CAPITOL OFFICE BUILDING

SENATE RULES AND ADMINISTRATION COMMITTEE

KEY CHANGES FROM ORIGINAL CONCEPTS:
EXTERIOR MODIFICATIONS

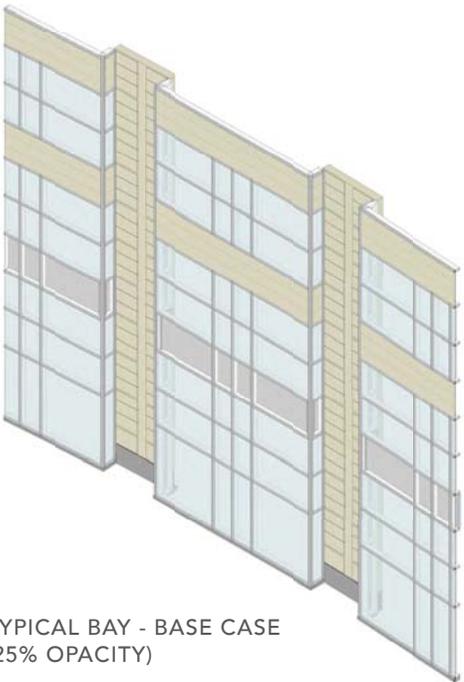
1. Elimination of exterior sun shade and columns
2. Elimination of reflecting pool
3. Mechanical moved to rooftop - creating interior space for 67 Senators
4. Reduction in conference room quantity and office size - creating interior space for 67 Senators
5. Simplification of the North facade - less articulation
Less glass on the South facade - more opacity
6. Reduction in the number of landscape trees
7. Reduction in the landscape paver scope
8. Elimination of the service tunnel at parking level
9. Elimination of the 'blade' at roof level
10. Elimination of skylight options at roof level and green roof
11. Simplification of interior material palette
12. Potential elimination of exterior stair and or elevator
